Recall Bulletin

SUBJECT: Lapbelt Pretensioner Locking Performance

MODELS: 2013 Buick Encore
2013 Cadillac ATS 4-Door
2013 Chevrolet Trax
and
Vehicles that were serviced with a suspect part:
2013-2014 Buick Encore
2013-2014 Cadillac ATS 4-Door
2014 Cadillac CTS Sedan (VIN A)

GM Recall #14171

3966508

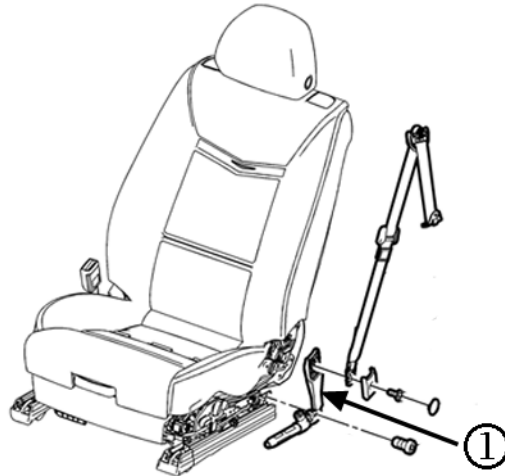
Dealers are to replace both front outboard lap belt pretensioners.

1. Remove the driver and passenger seat belt tensioner assemblies (1). Refer to *Front Seat Belt Anchor Plate Tensioner Replacement* in SI.
2. Install new driver and passenger seat belt tensioner assemblies. Refer to *Front Seat Belt Anchor Plate Tensioner Replacement* in SI.
